8/9.9 HP FourStroke Ignition Coil Test Specifications

Models Covered	Part Number
8/9.9 FourStroke 9.9 BigFoot FourStroke Service Manual	90-892248R01

Ignition Coil Primary Windings

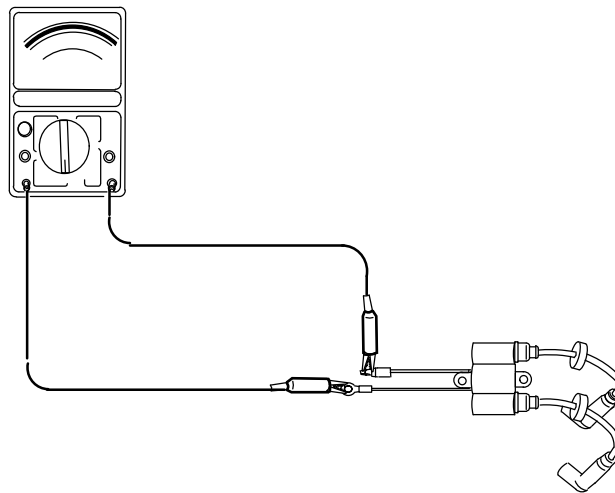
Mercury Marine has updated troubleshooting specifications for the ignition coil in the above listed service manual. Use the revised specifications provided when troubleshooting the ignition coil on the above mentioned models.

Meter Test Leads		Meter Scale	Reading (Ω)
Red	Black		
Orange	Black	R x 1	0.2-0.8
